15037-R08-A

11 July 2019

Old Granada Studios, Manchester

Stage 4 acoustic design report – zone 6

Zone 6 - GA Plan - Level 03

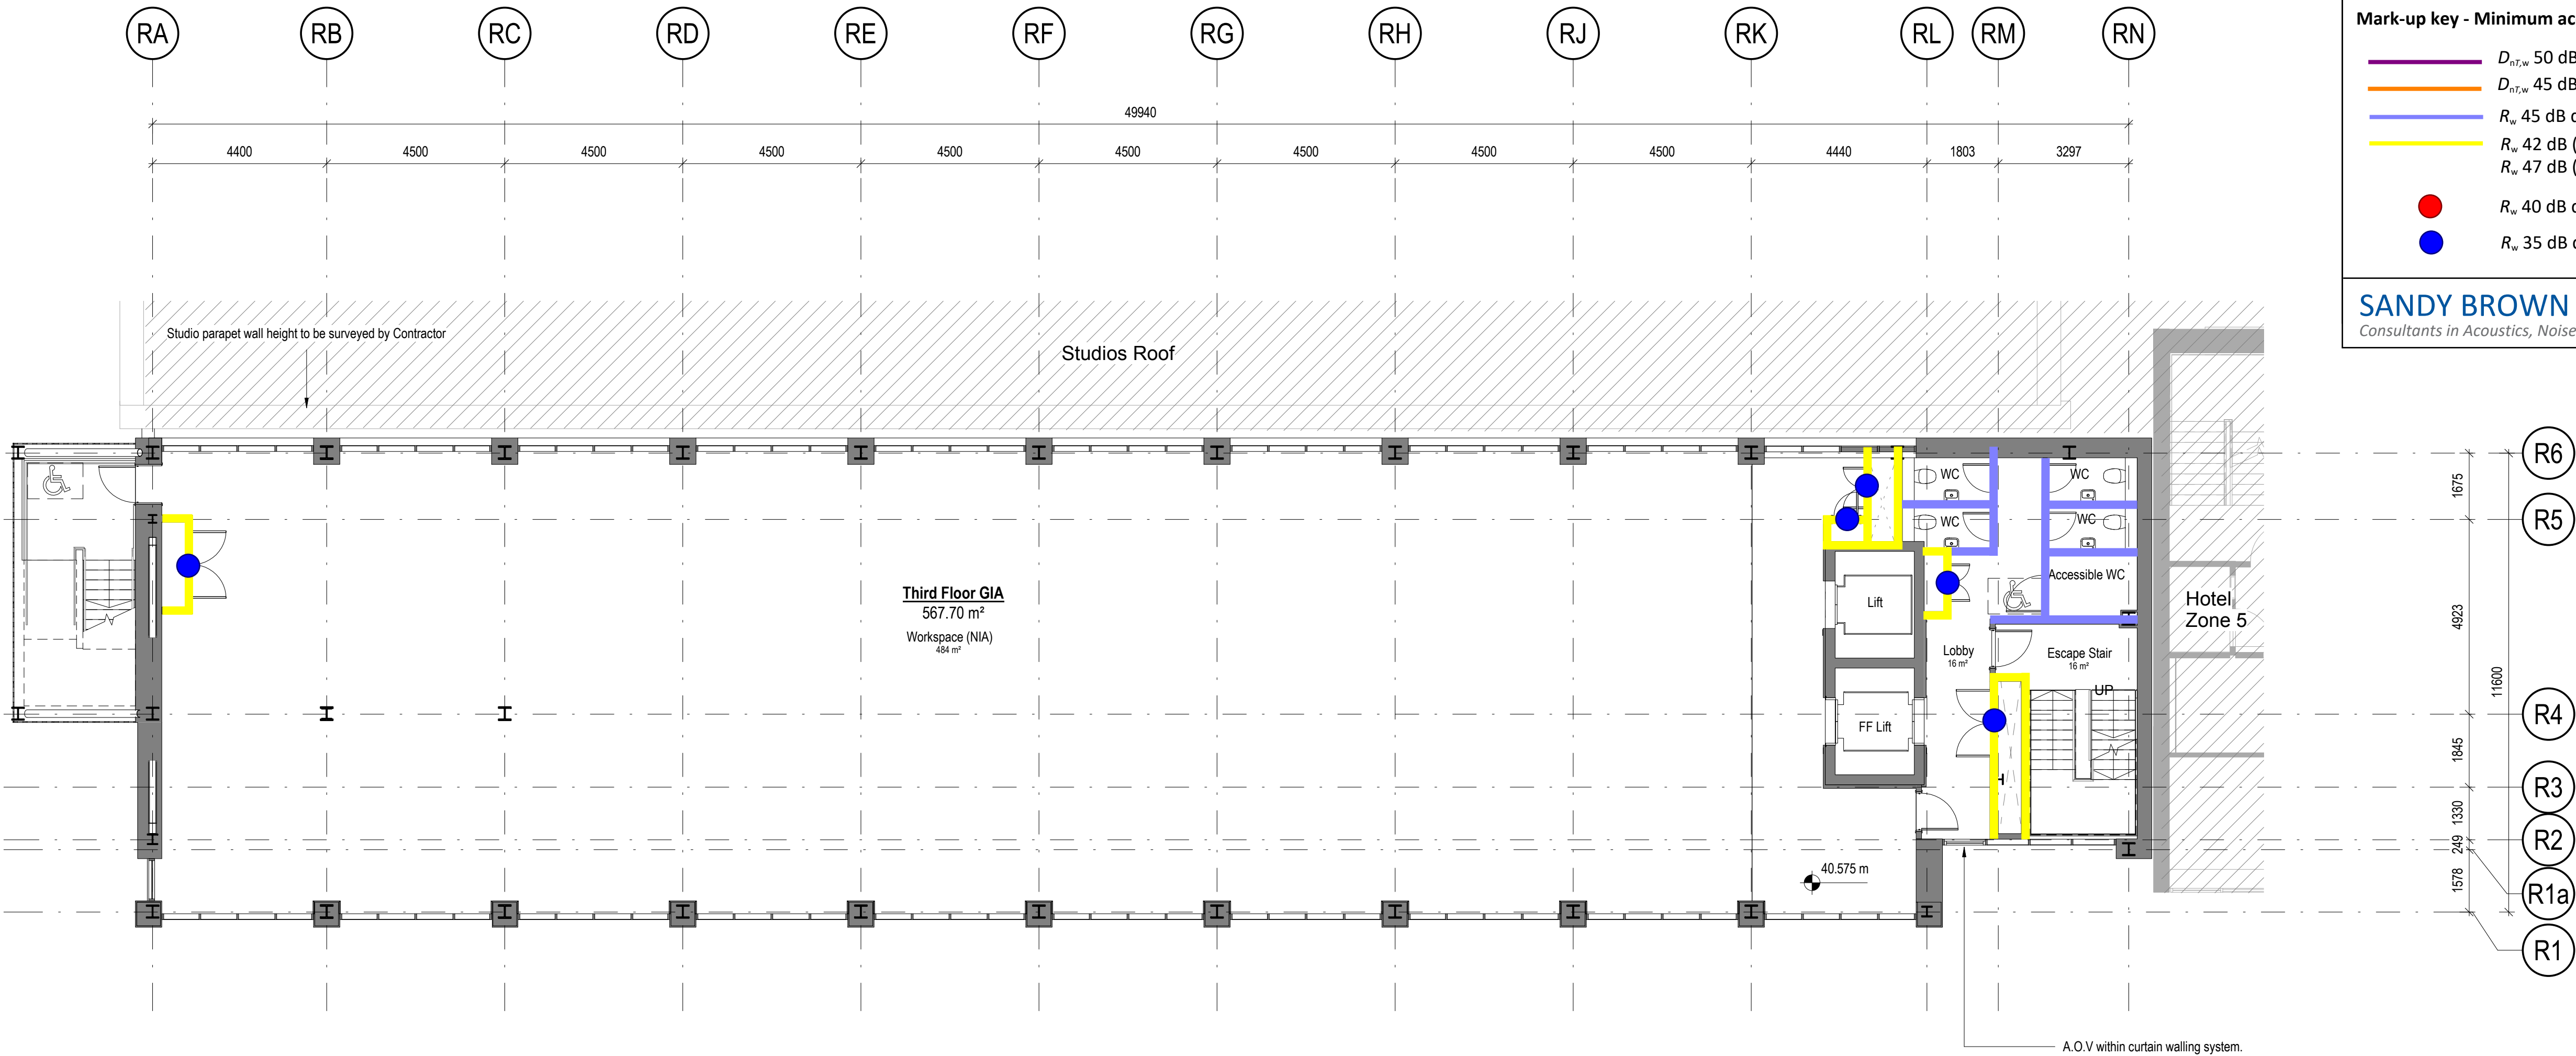
- $D_{nT,w}$ 50 dB partition
- $D_{nT,w}$ 45 dB partition
- R_w 45 dB drywall
- R_w 42 dB (electrical riser)
 R_w 47 dB (mechanical riser)
- R_w 40 dB door
- R_w 35 dB door

Zone 6 - GA Plan - Level 04

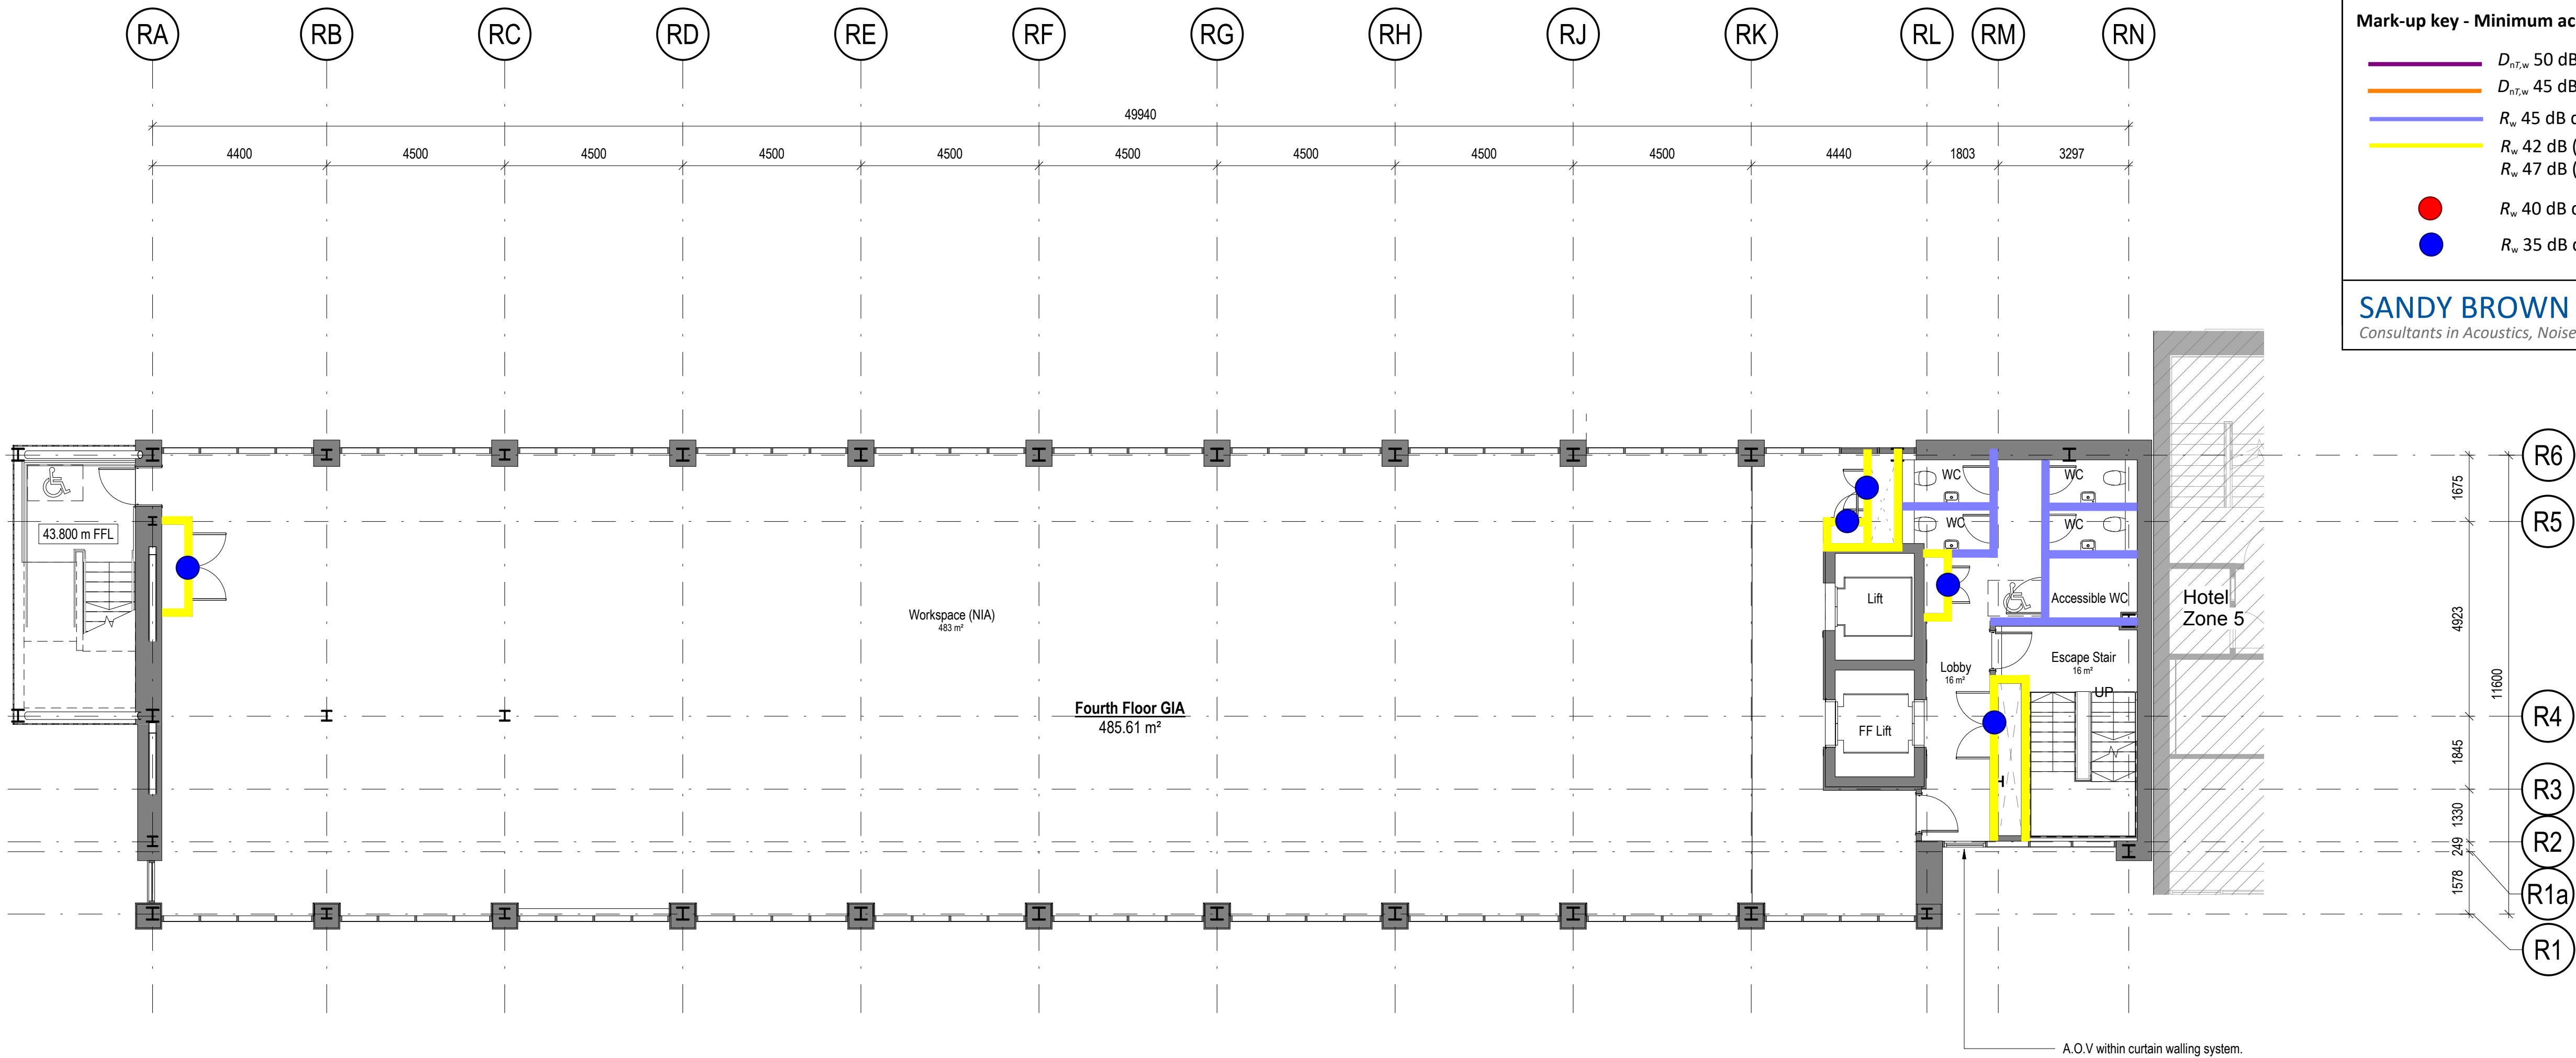
- $D_{nT,w}$ 50 dB partition
- $D_{nT,w}$ 45 dB partition
- R_w 45 dB drywall
- R_w 42 dB (electrical riser)
 R_w 47 dB (mechanical riser)
- R_w 40 dB door
- R_w 35 dB door

Zone 6 - GA Plan - Level 05

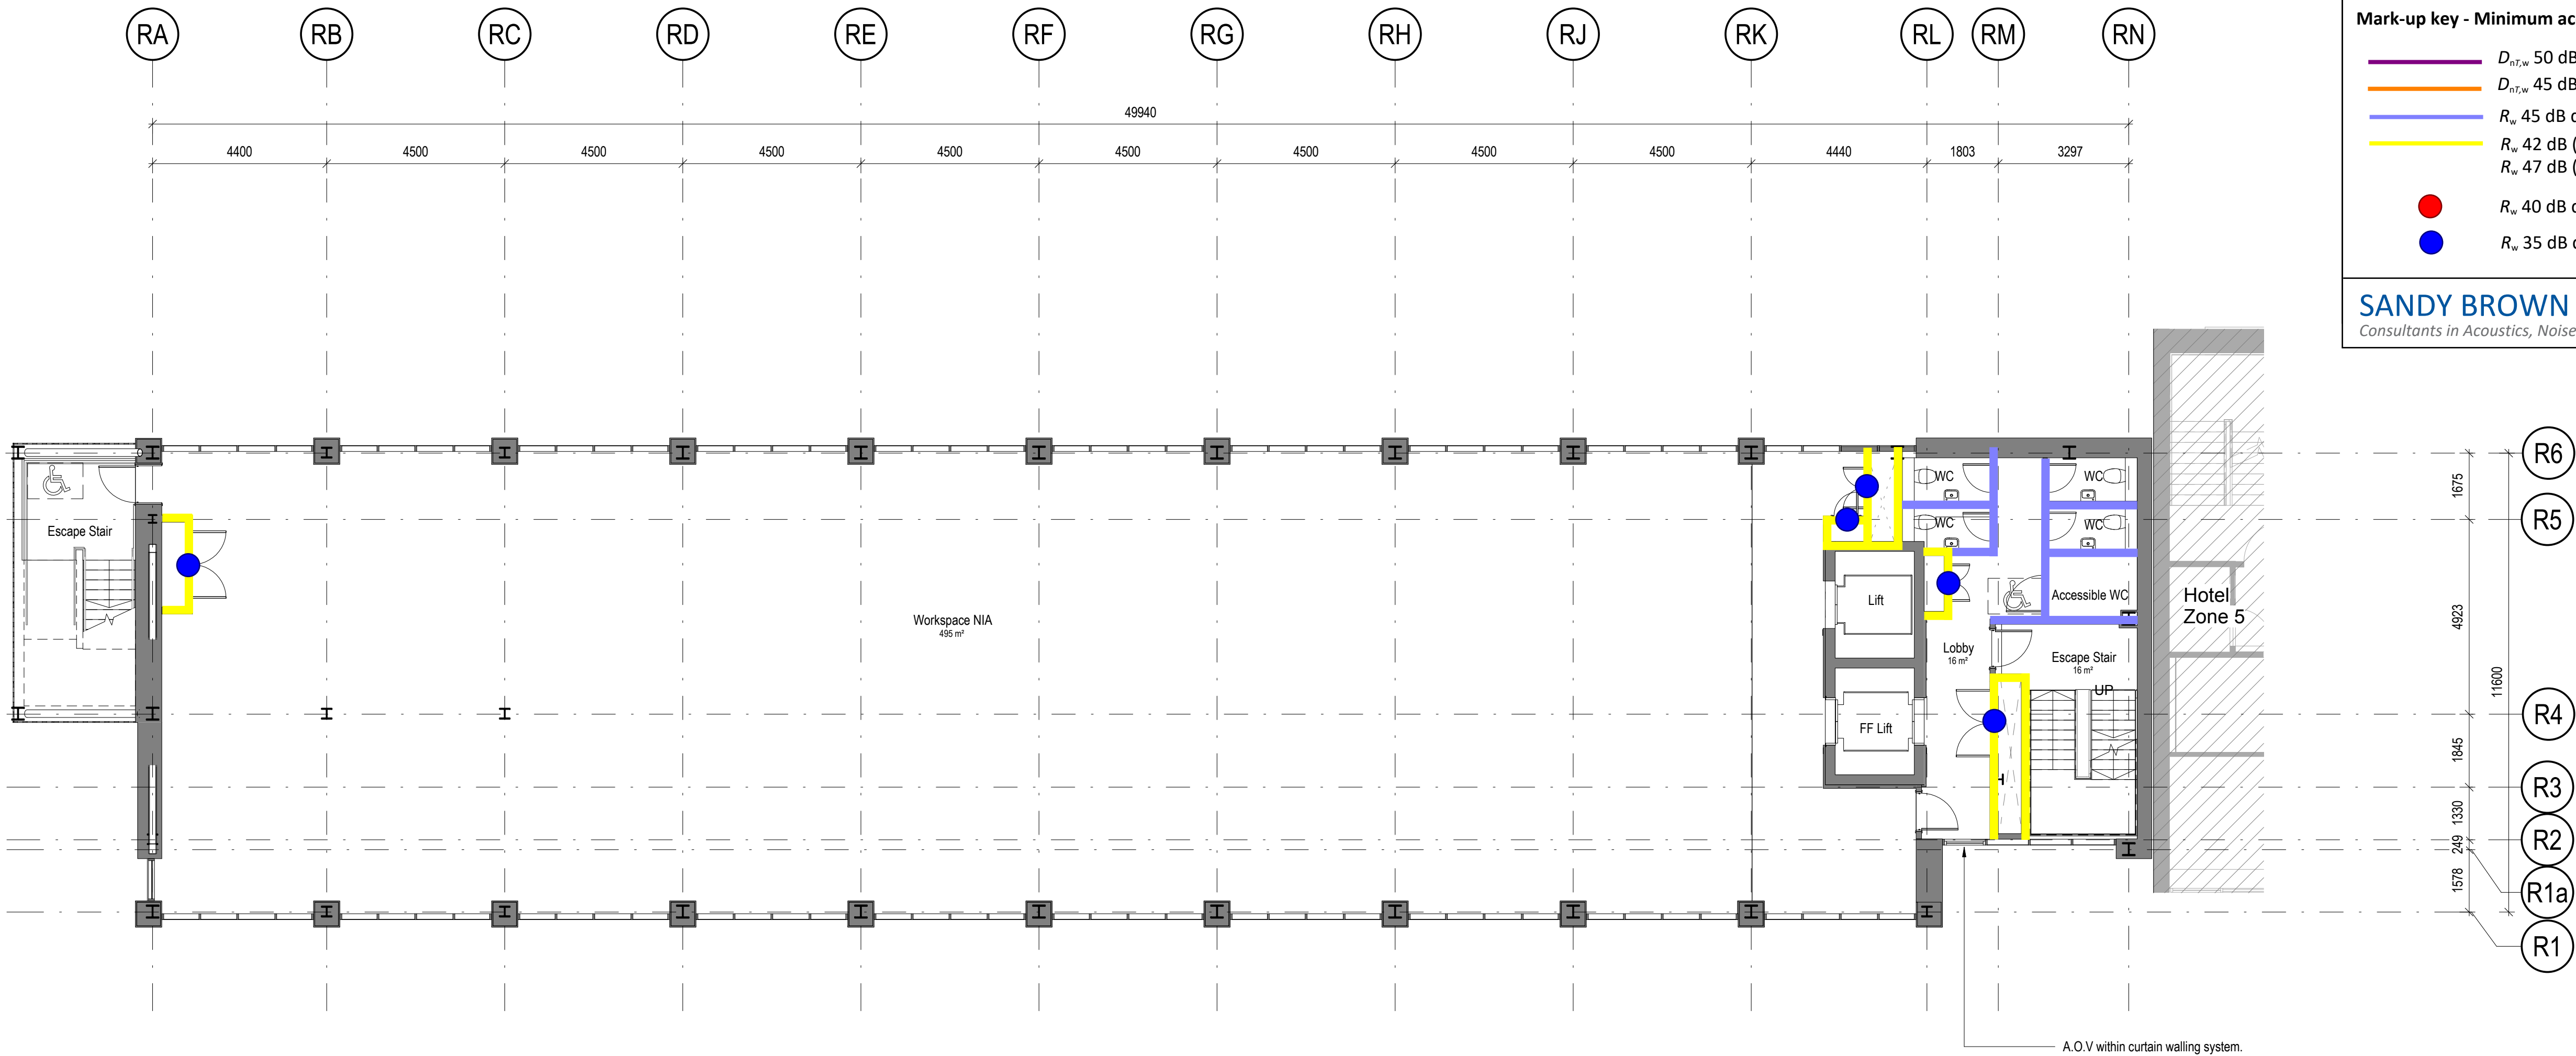
- $D_{nT,w}$ 50 dB partition
- $D_{nT,w}$ 45 dB partition
- R_w 45 dB drywall
- R_w 42 dB (electrical riser)
 R_w 47 dB (mechanical riser)
- R_w 40 dB door
- R_w 35 dB door

Zone 6 - GA Plan - Level 06

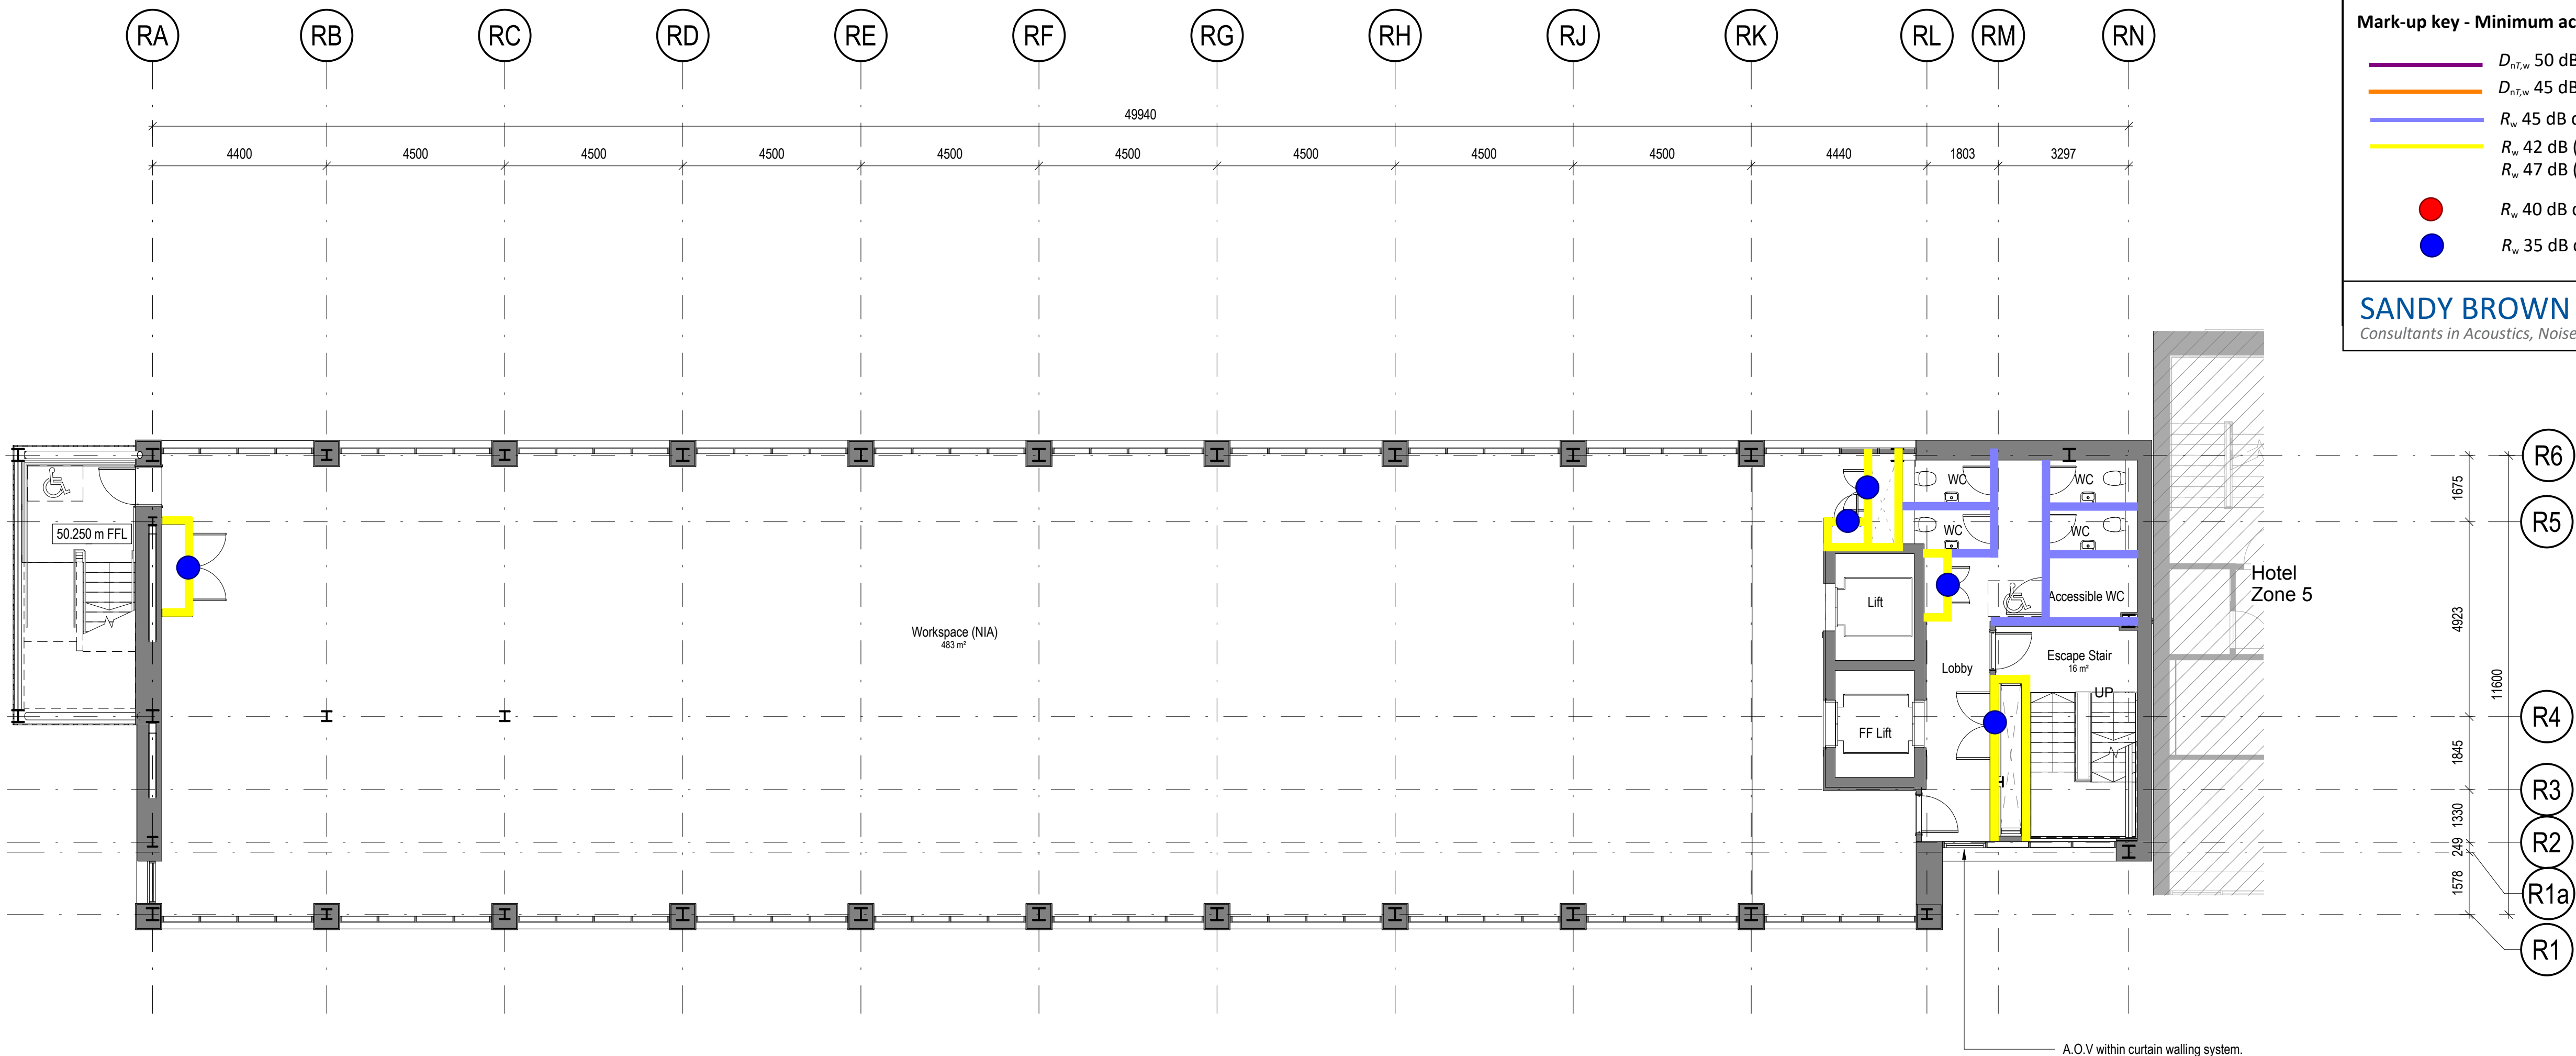
- Mark-up key - Minimum acoustic ratings**
- $D_{nT,w}$ 50 dB partition
 - $D_{nT,w}$ 45 dB partition
 - R_w 45 dB drywall
 - R_w 42 dB (electrical riser)
 R_w 47 dB (mechanical riser)
 - R_w 40 dB door
 - R_w 35 dB door
